Attachment II

Marked Up Ginna Station Technical Specifications

Attachment IV

Fuel Handling Accident Inside Containment Dose Consequence Analysis for Ginna Station

FIGURE 1. PLANT CONFIGURATION

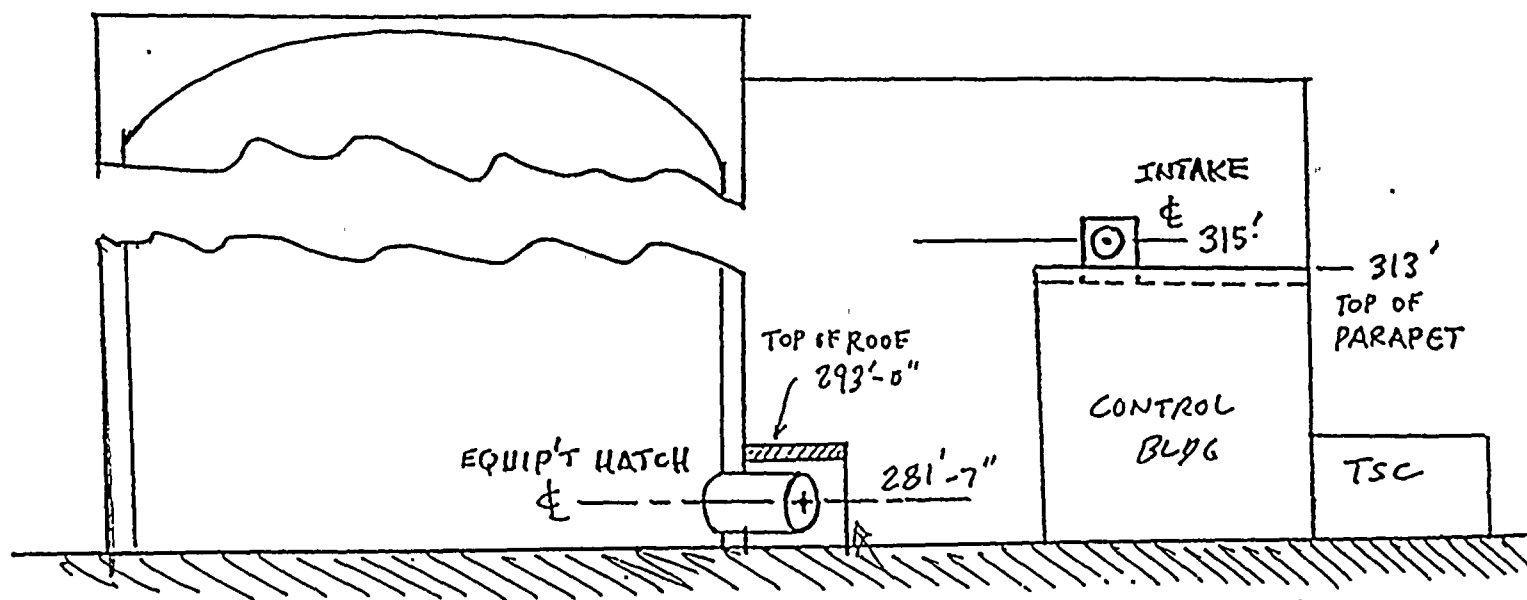
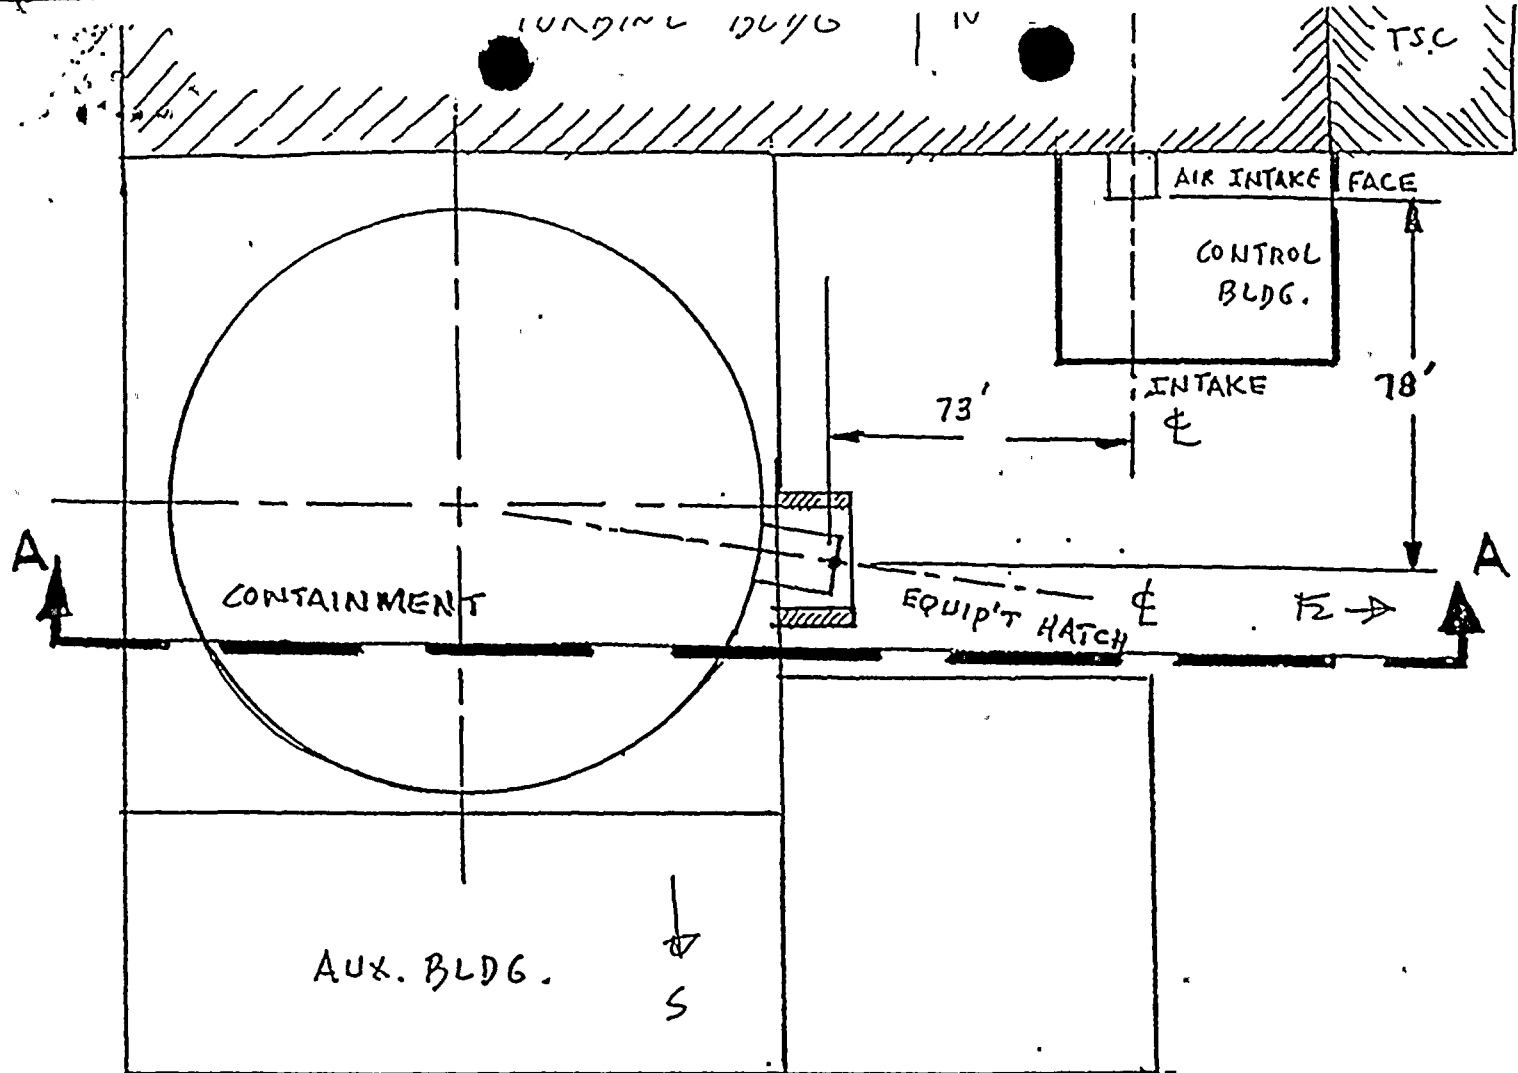
The plant configuration is shown in Figure 1. The critical features as shown on this figure is that the control room intake source is on top of the control room building.
